SERVICE BULLETIN

ALL LEGACY MODELS

FRONT END "POP" NOISE

Figure 1

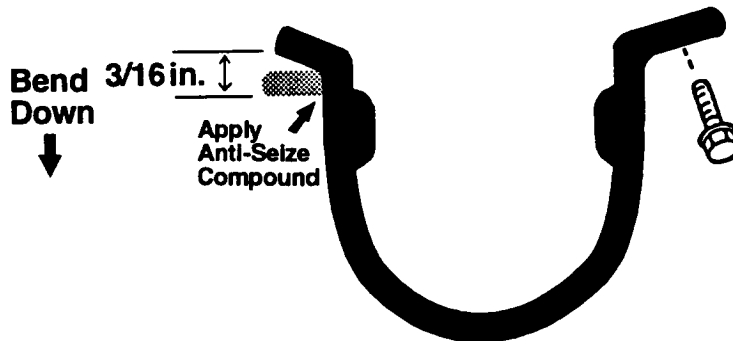
If you encounter a customer complaint of a noise coming from the front end when turning, (similar to a small stone hitting the floor pan), pivoting front stabilizer bar bushing clamps may be the cause. Use the following information to adjust the clamps:

- o Remove both right and left bushing clamps. Use Section 4-1 of the applicable Legacy Service Manual.
- o Bend the tab hook approximately 3/16". See Figure 1.
- o Coat the underside of the hook with anti-seize compound.
- o Re-install in reverse order of disassembly.
